PRE-BID ADDENDUM No. 001
for
LITTLEFIELD TOWNSHIP
HAY LAKE MARINA PARK
MARINA AND SITE IMPROVEMENTS

Date of Issue: Monday – November 13, 2018

SHEET PILE WALL DETAILS
HAY LAKE MARINA PARK
LITTLEFIELD TWP, EMMET CO., MI

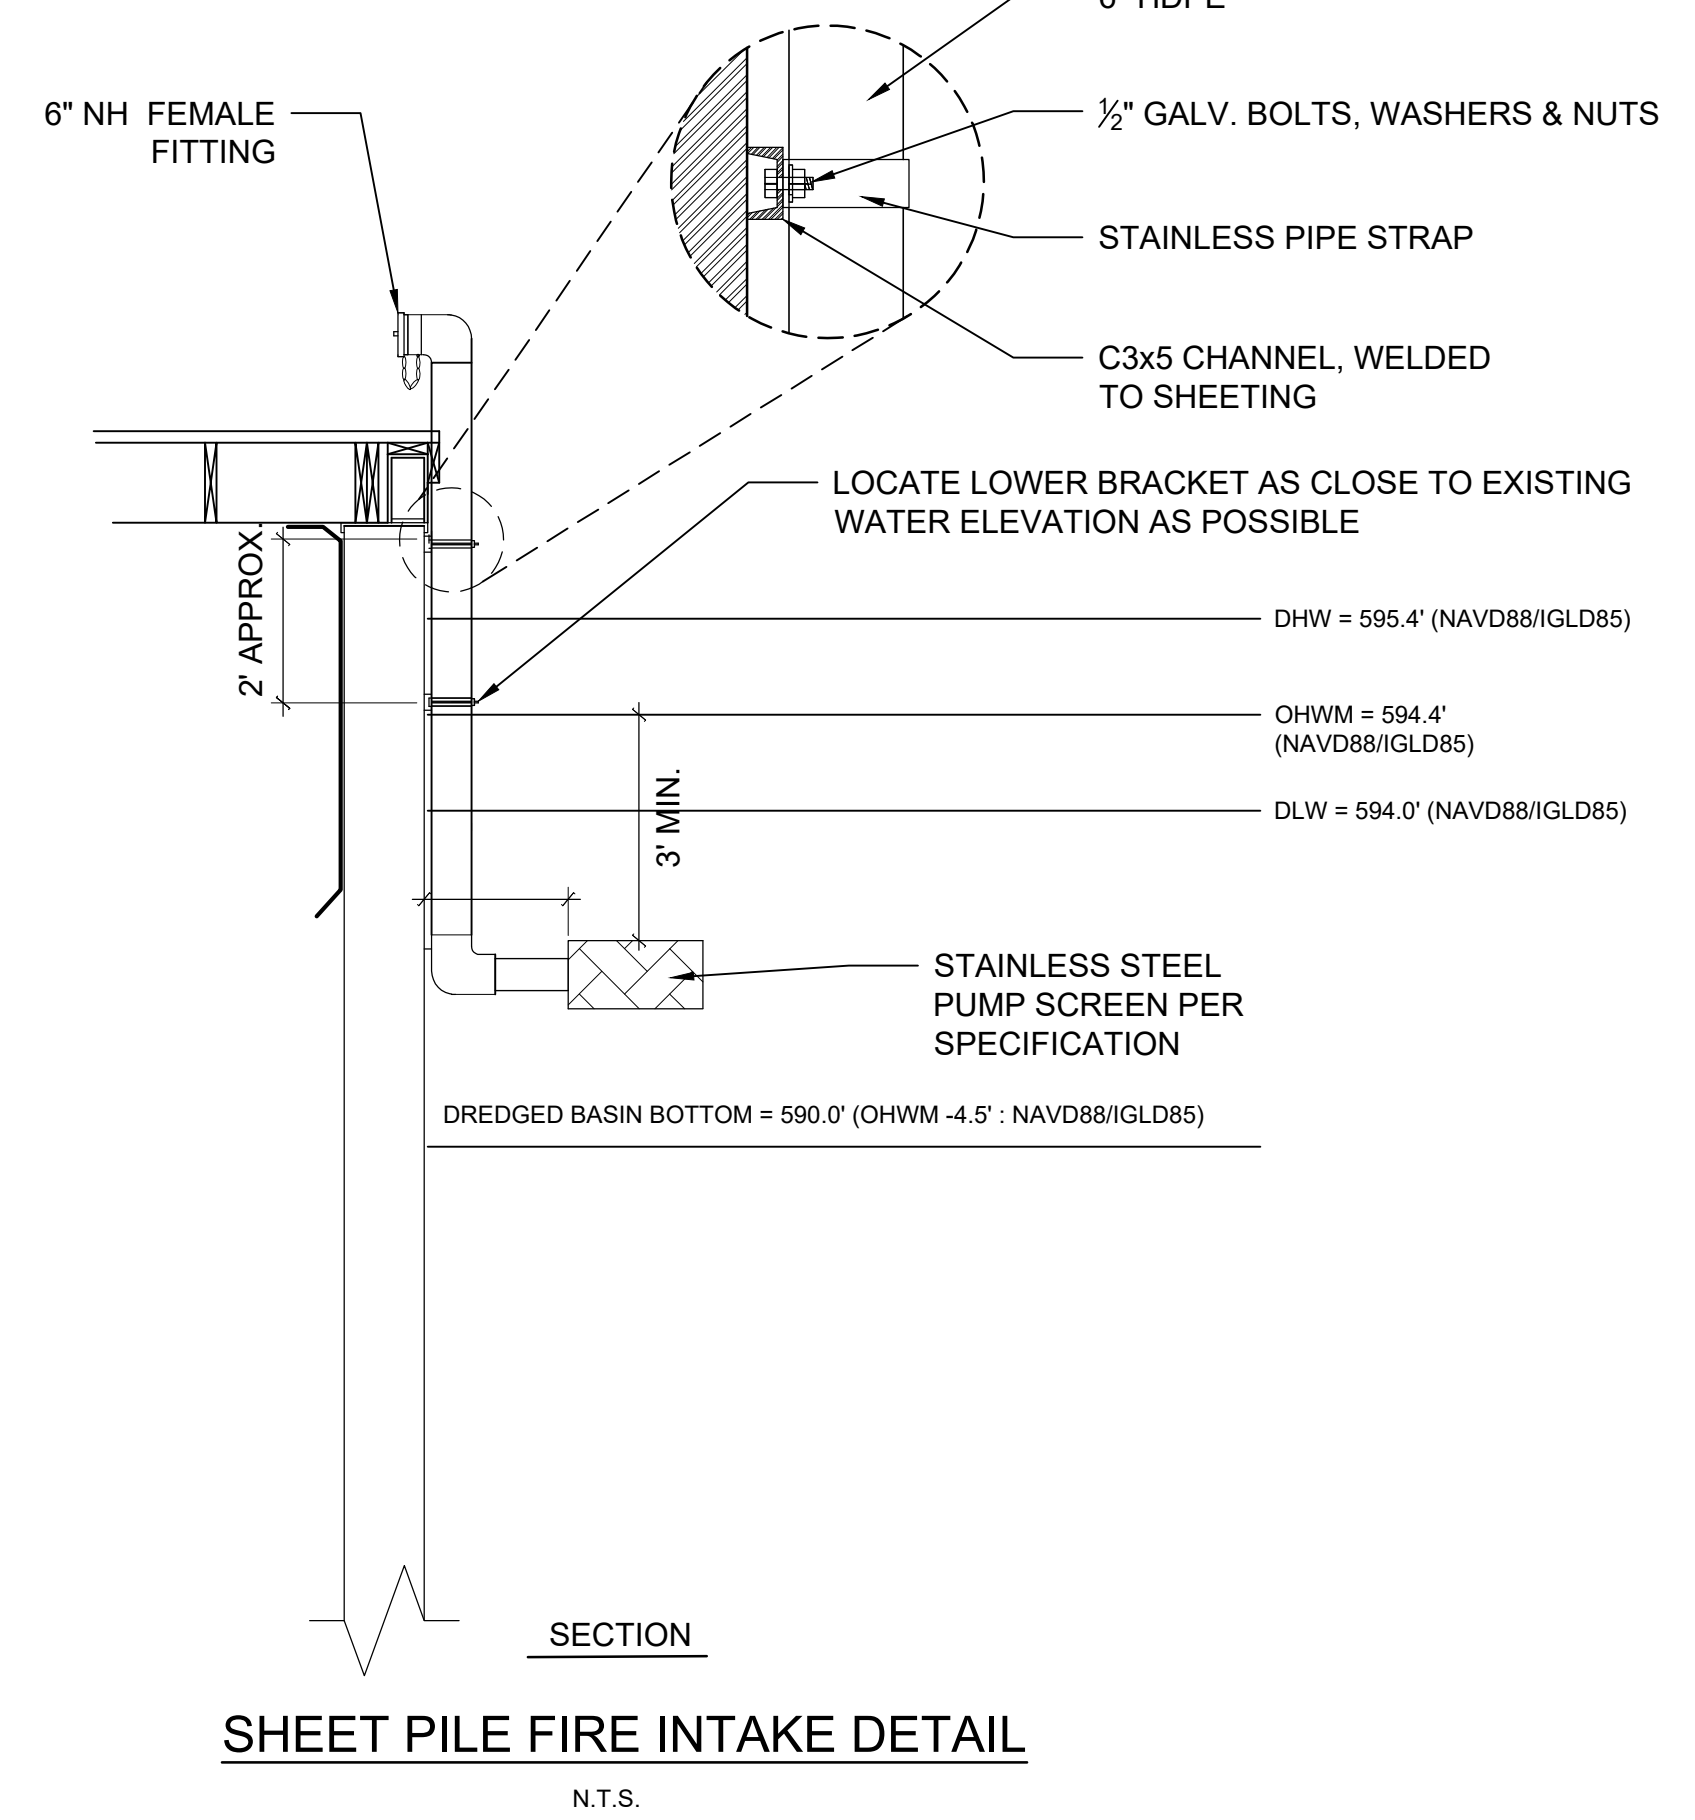
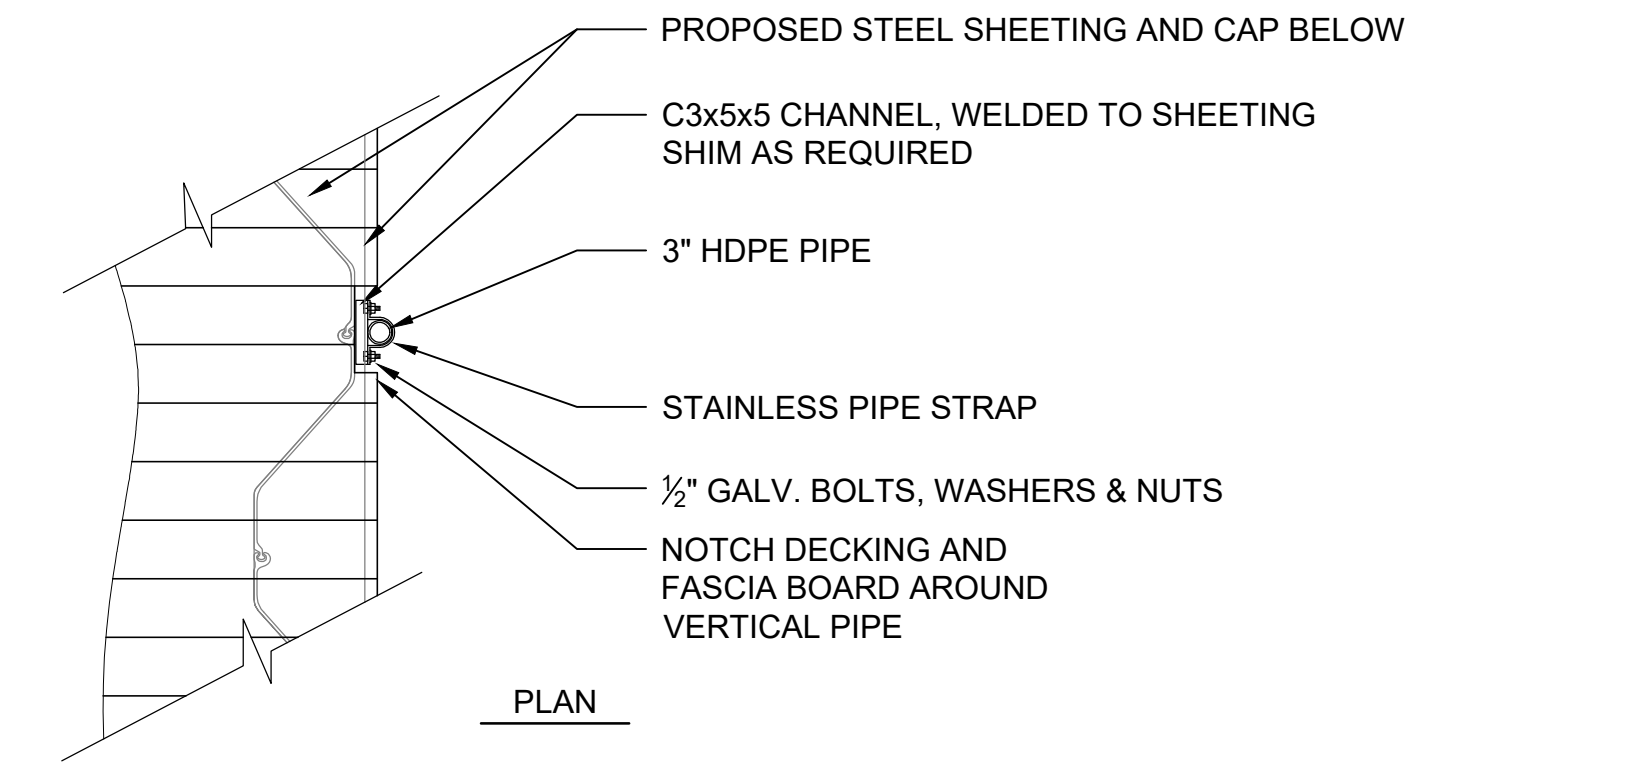
SHEET S9: See updated fire intake detail with new call out for 6" NH female connection and 6" HDPE intake pipe.

Q: Is it correct that galvanized bolts should be used for sheet pile tieback and rod connections, and zinc or cadmium for sheet pile waler connection (details sheet S9)

Q: Are the sheet pile system waler spacers on top of or between the two c-channels?

A: Yes

A: Between

PUMP STATION - PROFILE

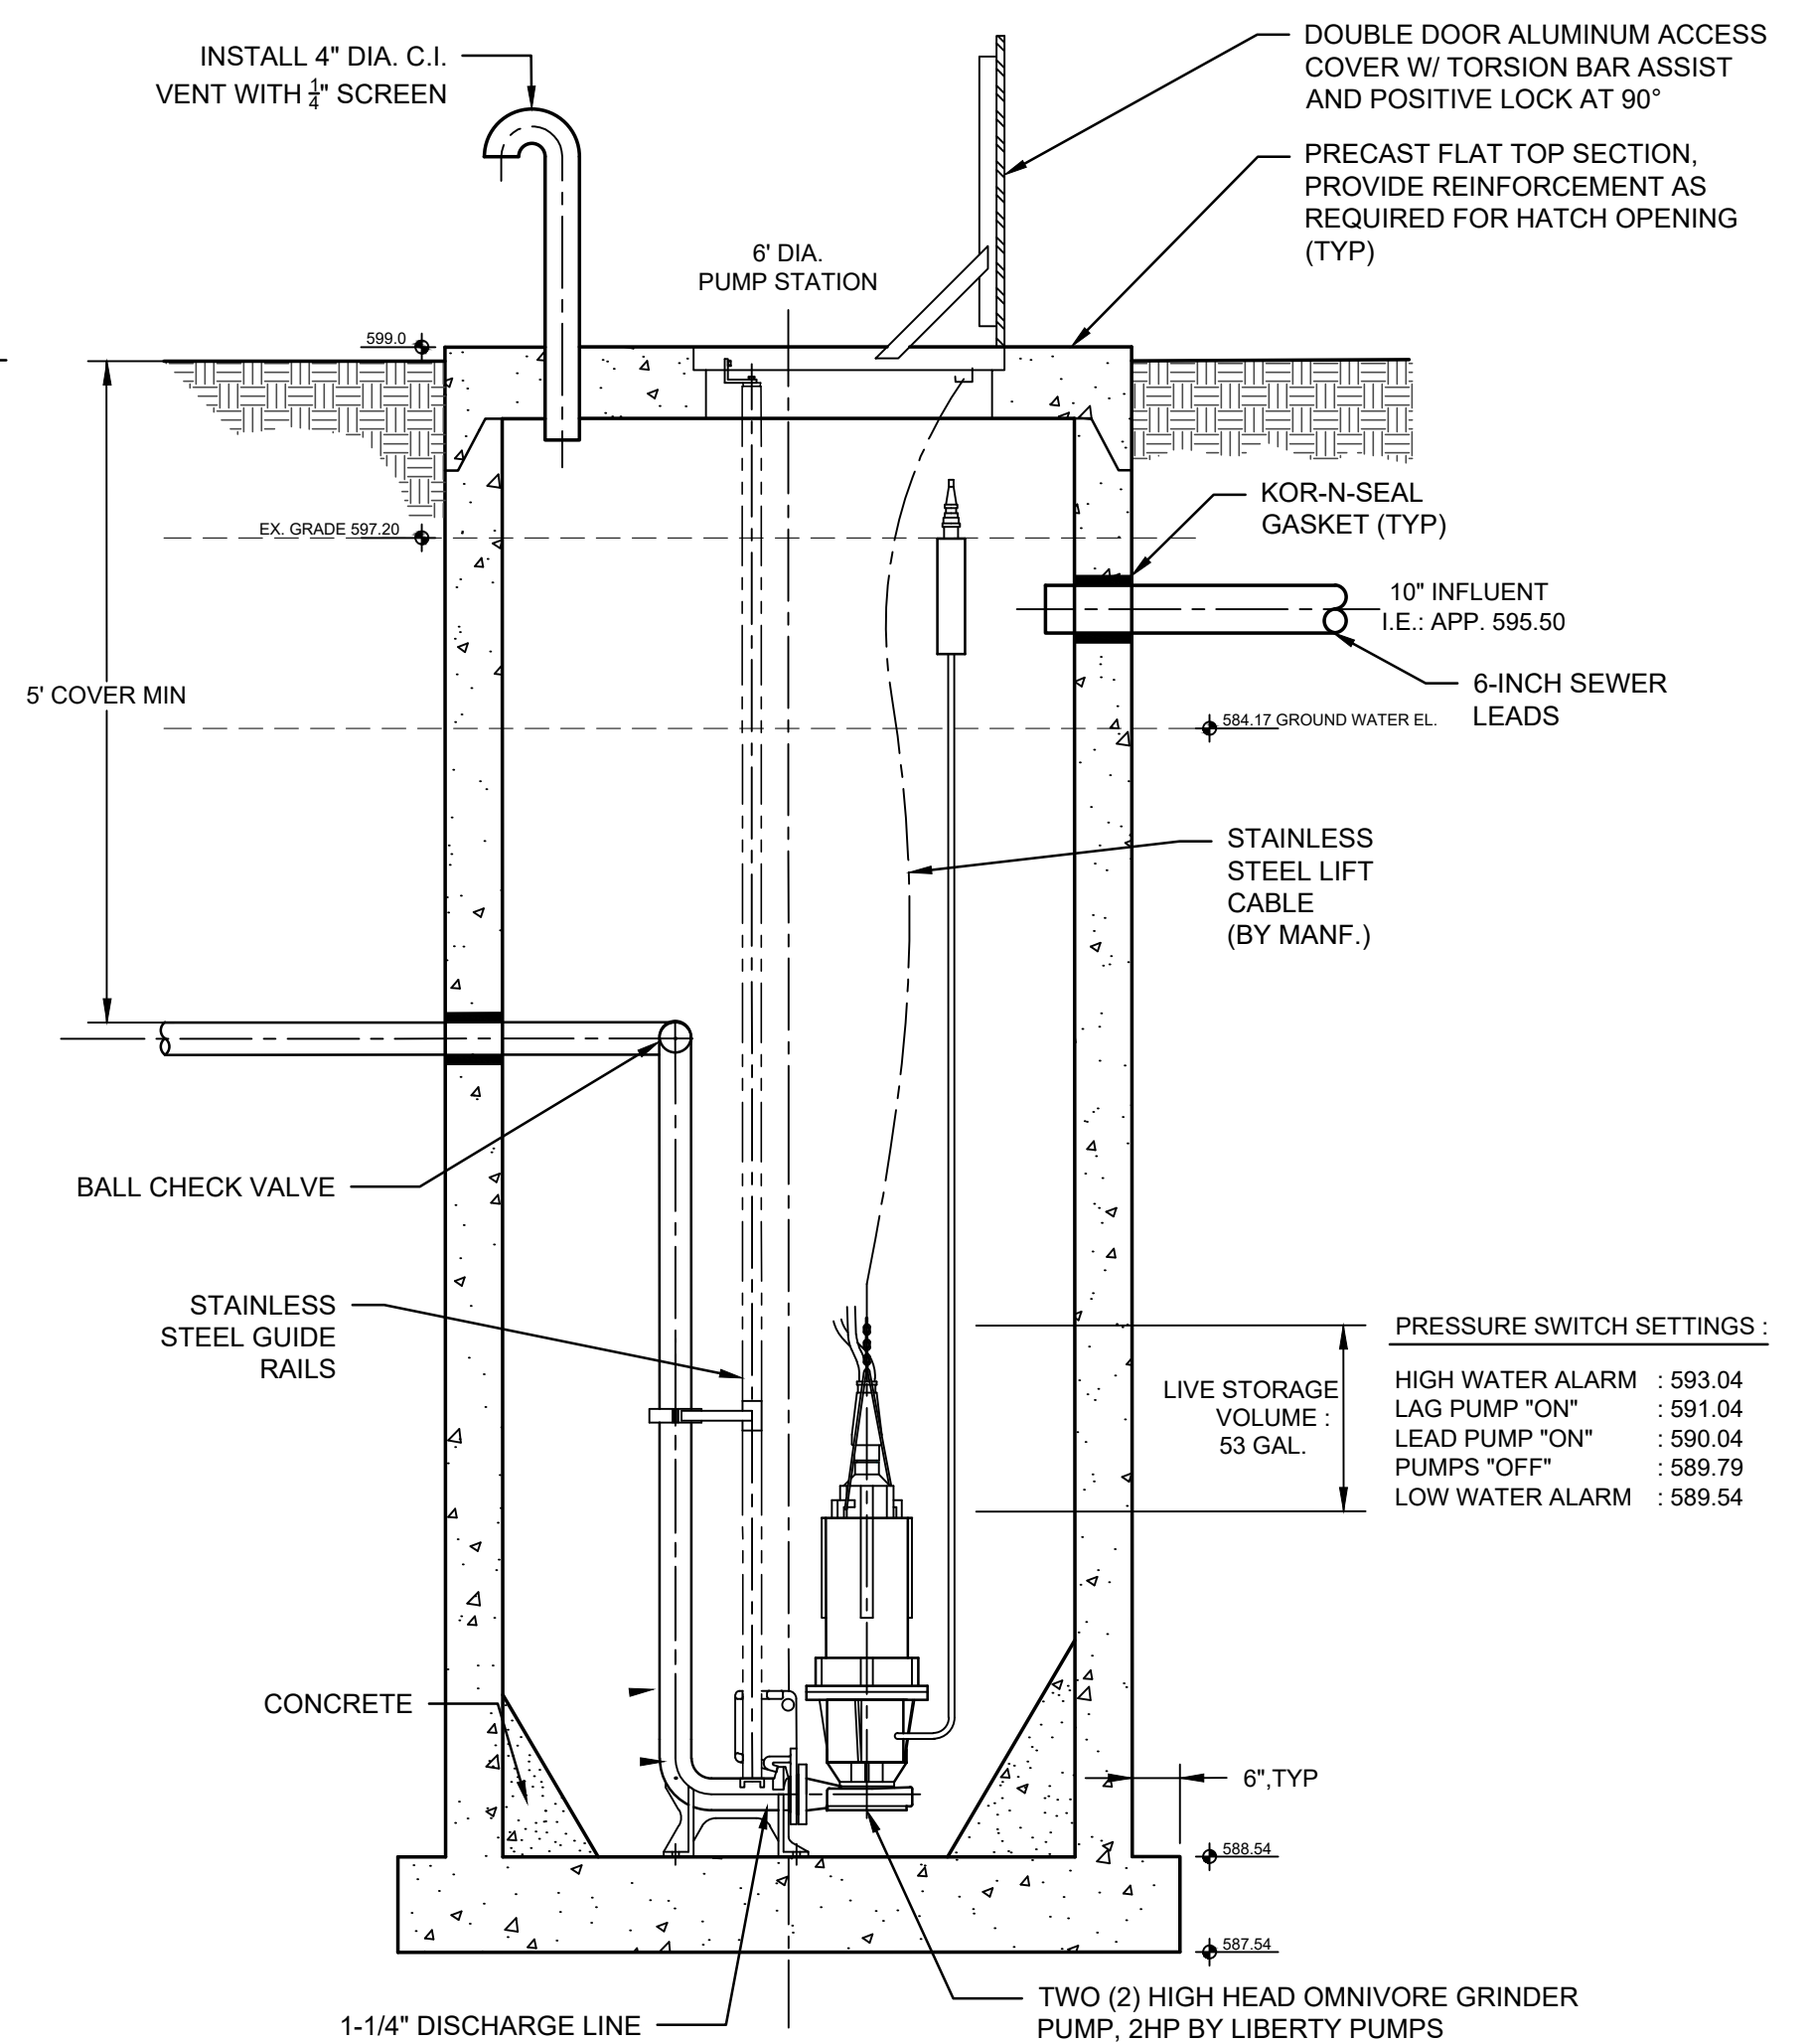
SHEET S14: See updated Pump Station – Profile detail with relocated ball check valve to vertical position along discharge line. Change minimum shutoff head in pump requirement notes from 190' to 185'.
